SRF No. 0148483
 County Project No. 091101

**CSAH 112 – Phase 1
 Project Advisory Committee (PAC) Meeting
 June 17, 2015; 8:00 am – 10:30 am
 Orono City Hall
 MEETING RECORD**

Subject: CSAH 112 Phase 1 Final Design (Willow Drive to Wolf Pointe Trail)
Hennepin County Project No. 091101

6' OFFSET

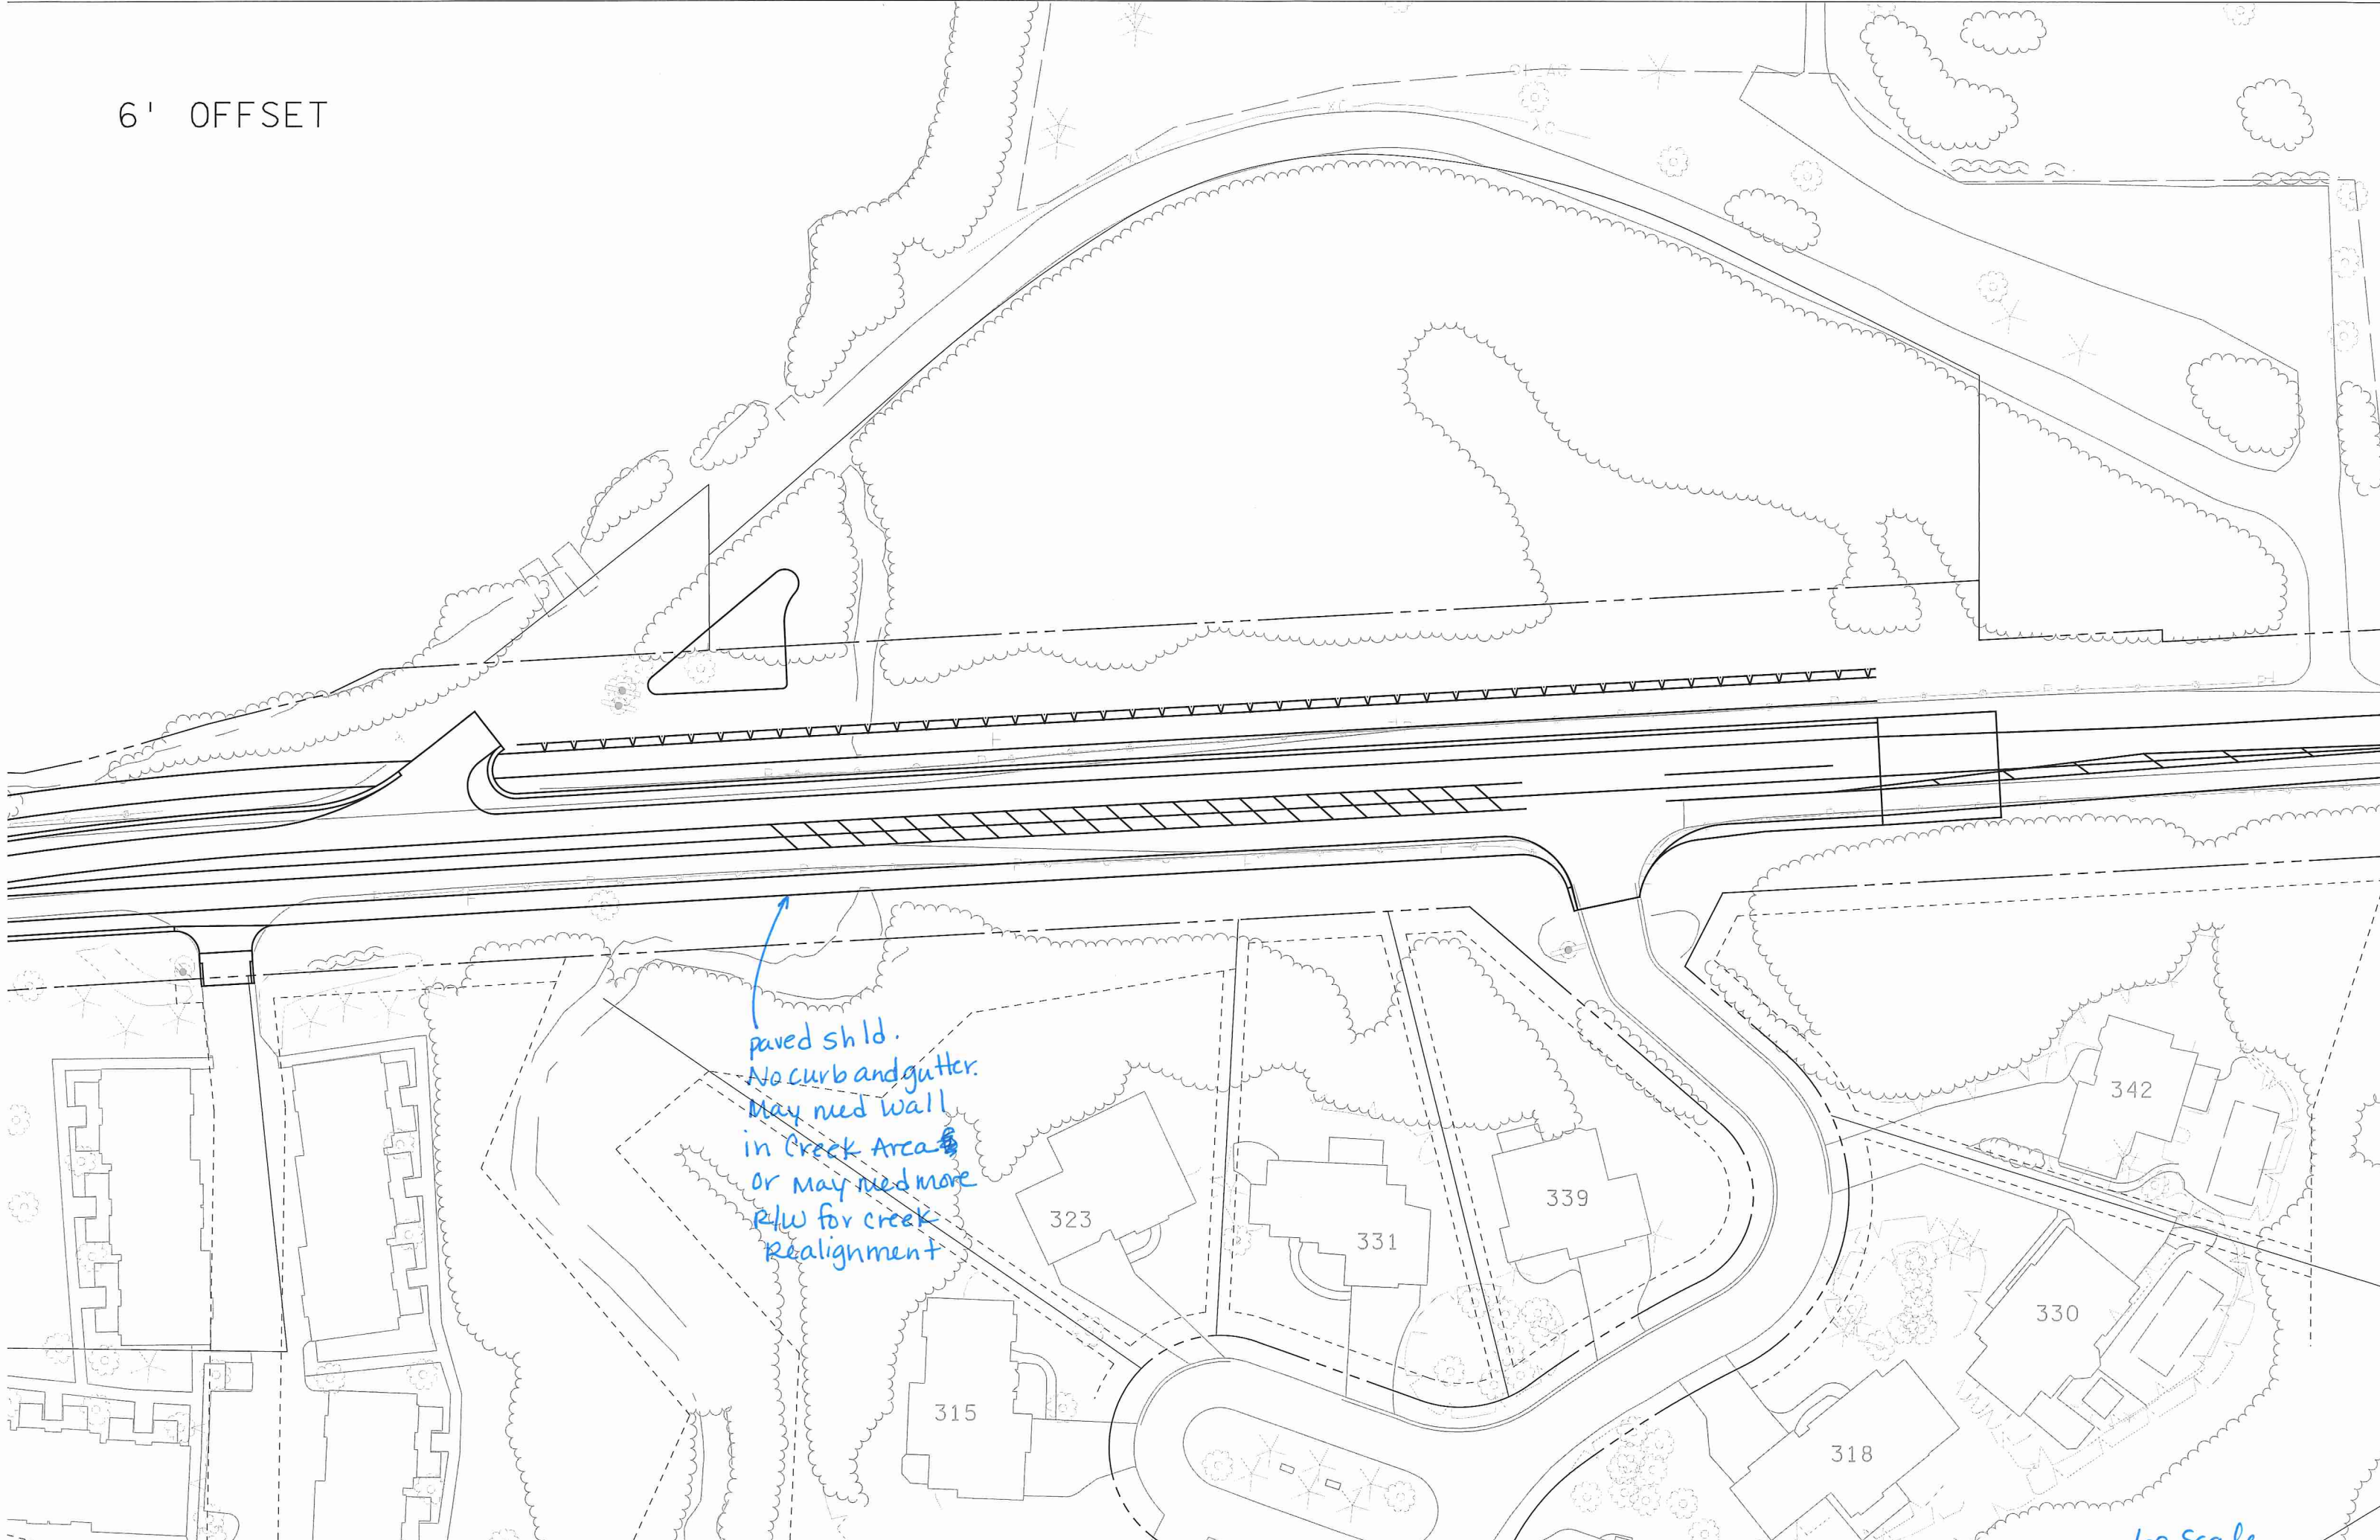
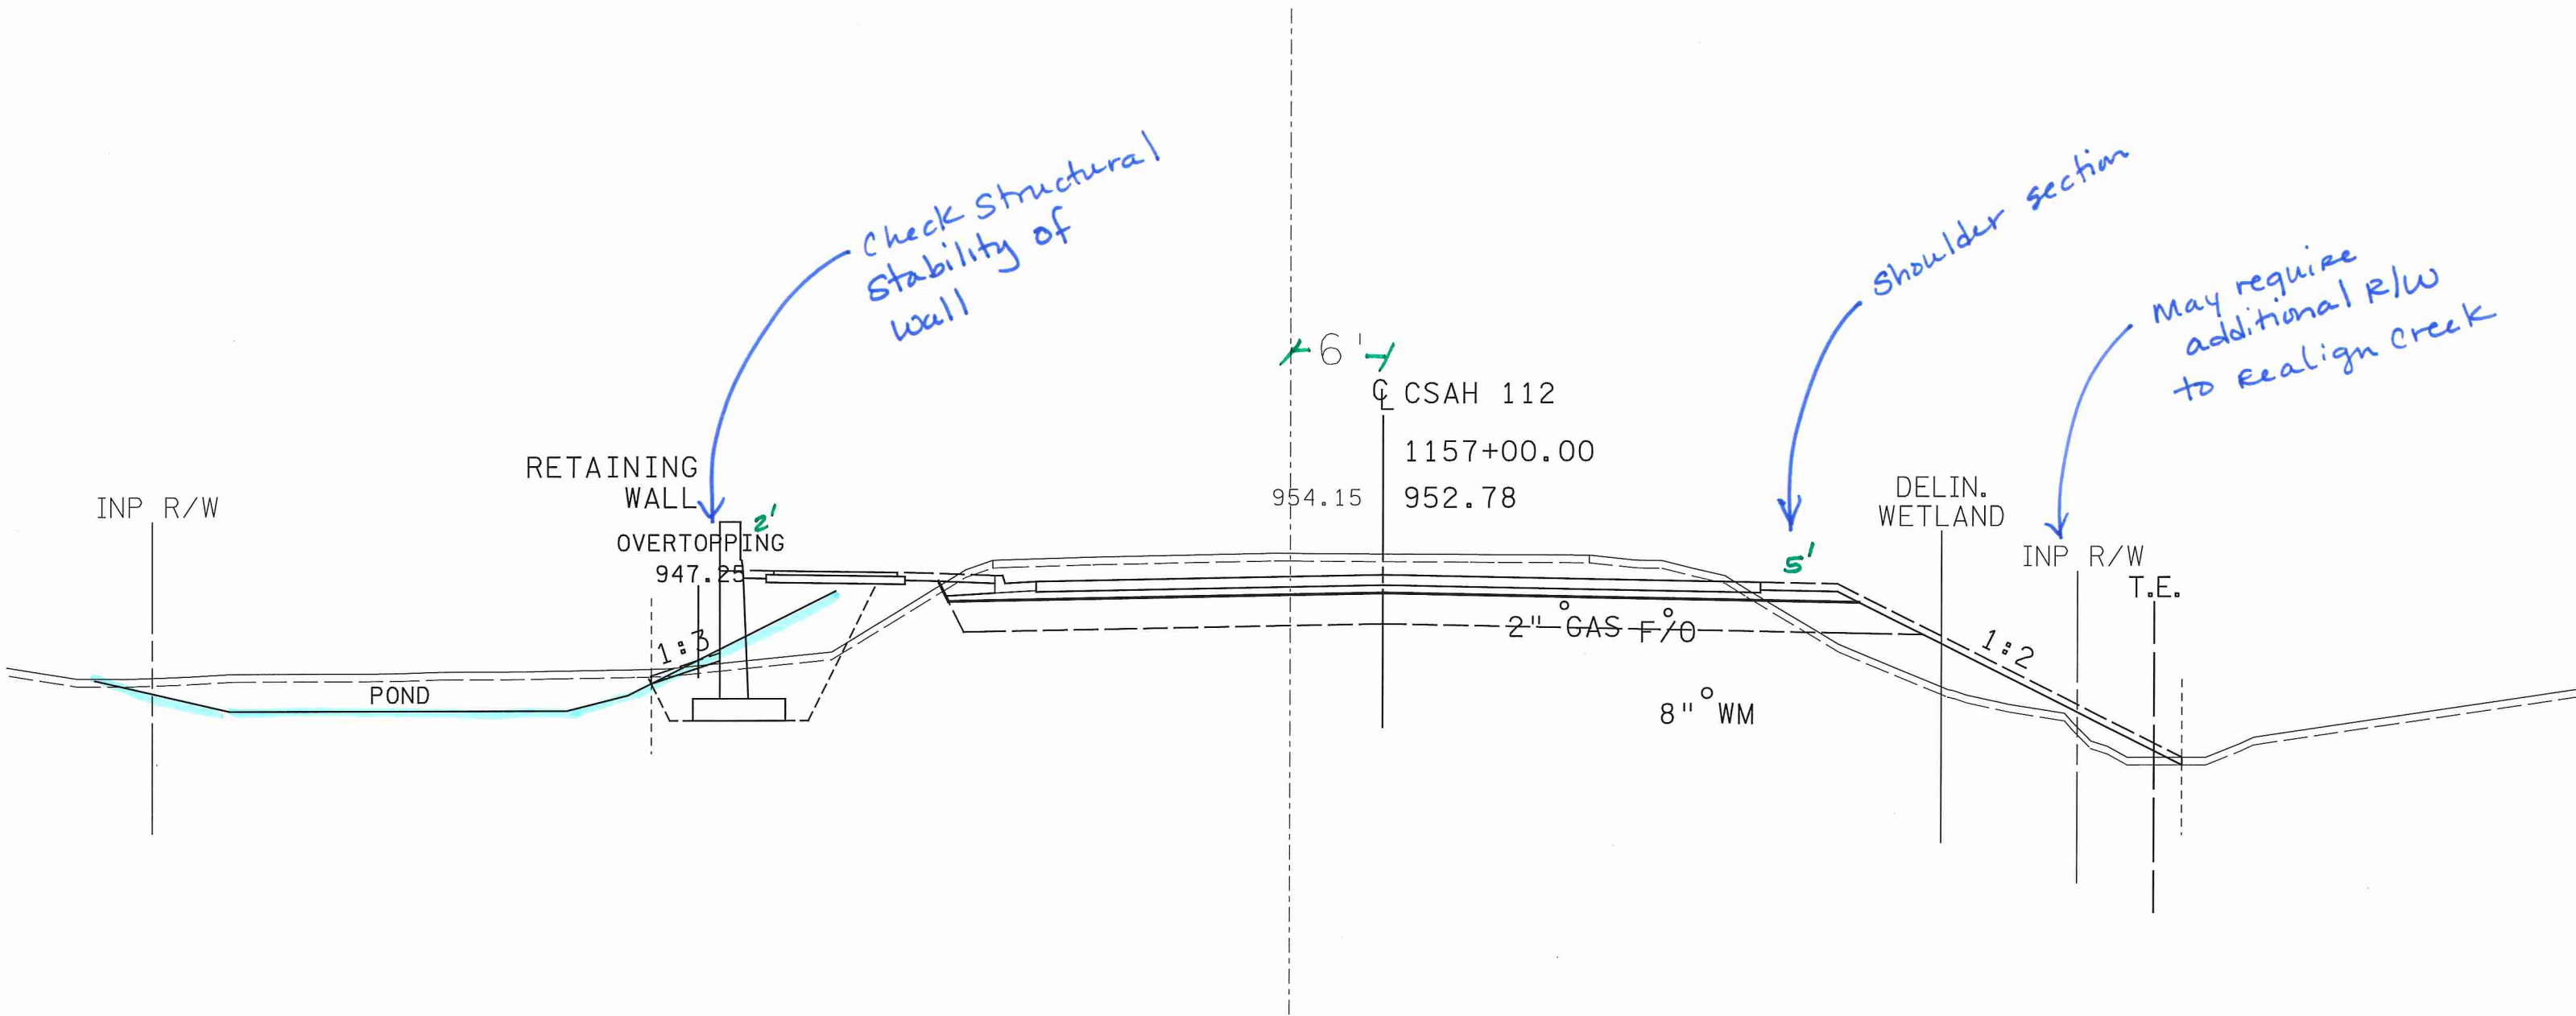
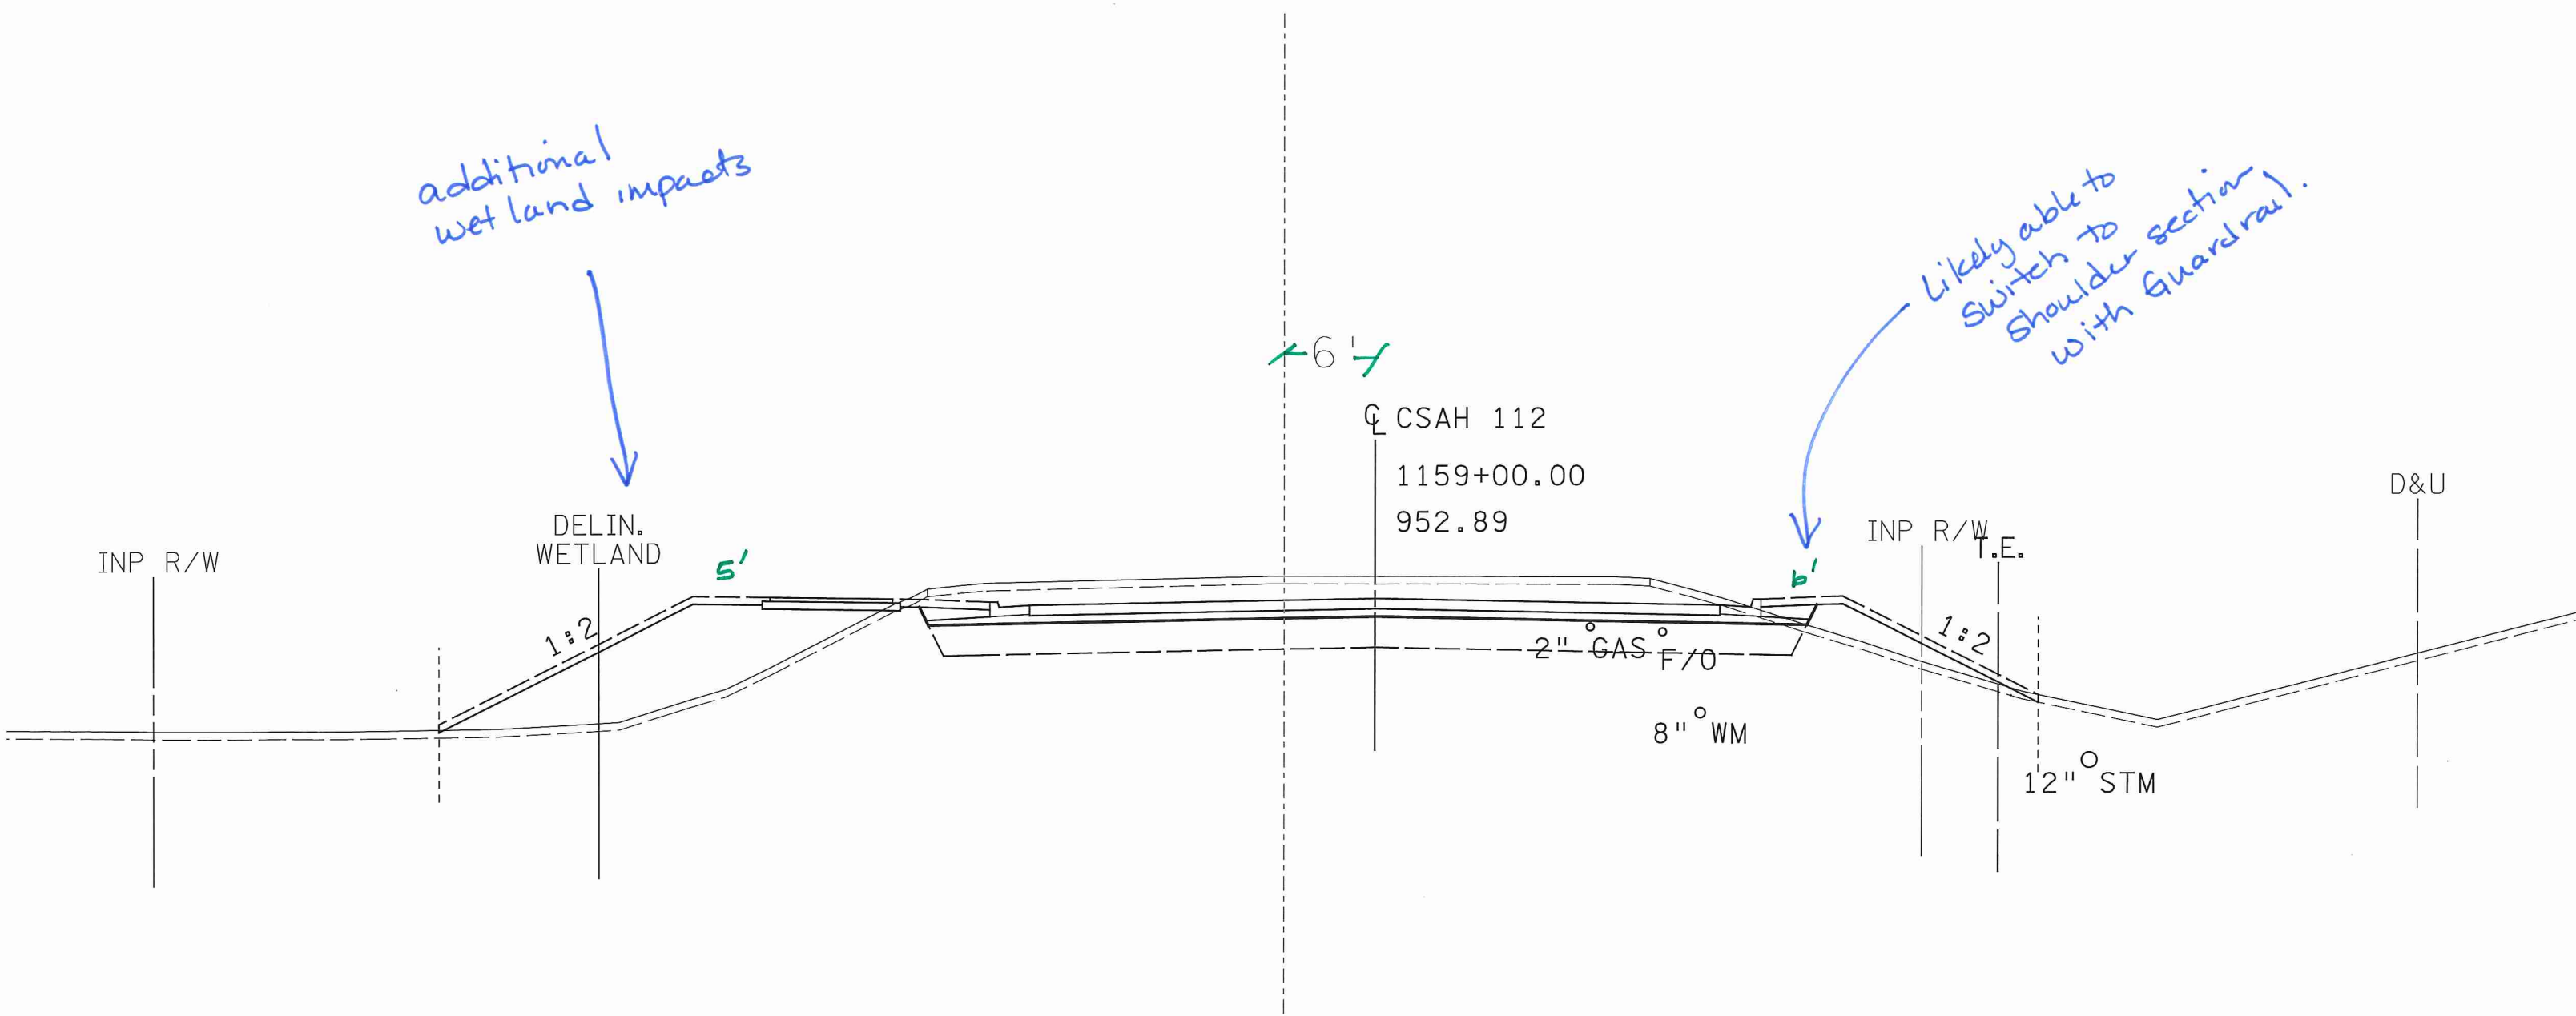
Nate described three (3) additional graphics (1 plan view & 2 cross sections) which illustrate the 6.0-foot centerline offset. He noted the basis for the 6.0-foot offset was developed by assuming that Wall G was deleted and using a 1:2 grading slope along the south embankment, similar to the current slope. Reviewing the cross sections for this option, Nate noted that a retaining wall would be required along the north side to minimize both wetland and stormwater treatment impacts. He mentioned this wall would most likely be longer than the wall needed in the 9.5-foot offset option; however, this option is based upon deleting Wall G from the south side.

paved shld.
No curb and gutter.
May need wall
in Creek Area
or may need more
R/W for creek
Realignment

additional wet land impacts

Likely able to switch to shoulder section with Guardrail.
